SERVICE BULLETIN

MTB-31-02

INDICATING/RECORDING SYSTEMS - FLIGHT HOUR METER REPLACEMENT

Figure 1. Flight Hour Meter Installation (Sheet 1)

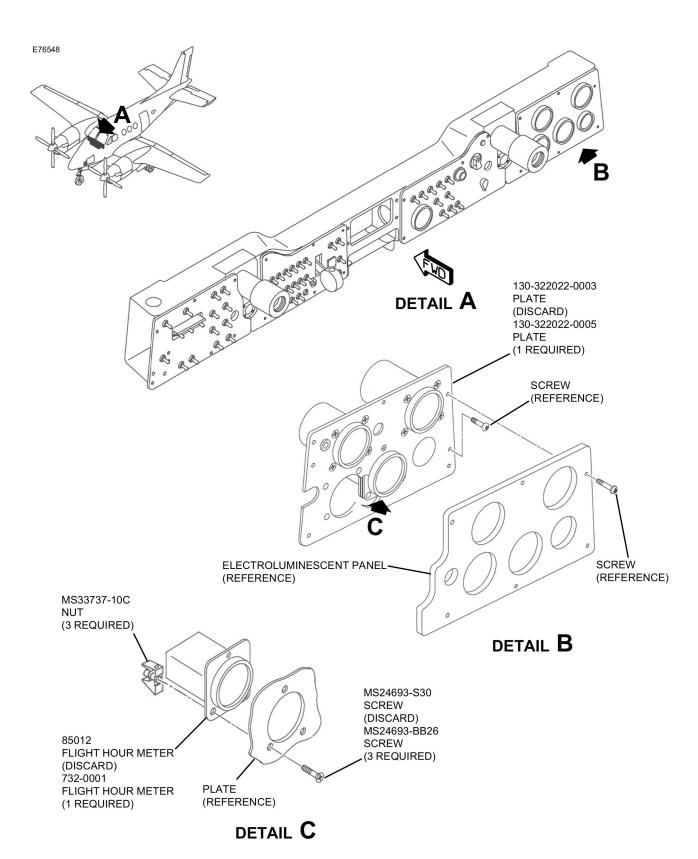
The existing flight hour meter is obsolete.

This service document provides parts and instructions to remove and replace the flight hour meter.

- 2. (Refer to Figure 1, Sheet 1.) Remove and retain six screws that attach the electroluminescent panel and plate to the sub-panel support structure.
 - Retain the electroluminescent panel.

- 9. Discard the 130-322022-0003 Plate.
- 10. Install the Air Temperature Gauge, Vacuum Indicator, Pneumatic Pressure Gage, Oxygen Gage Assembly to the new 130-322022-0005 Plate using the retained hardware.

- 11. Install the new 732-0001 Flight Hour Meter to the 130-322022-0005 Plate using the three MS24693-BB26 Screws and three MS33737-10C Nuts.
- 12. Remove the tags and connect the electrical wires to the 732-0001 Flight Hour Meter and Air Temperature Gauge.
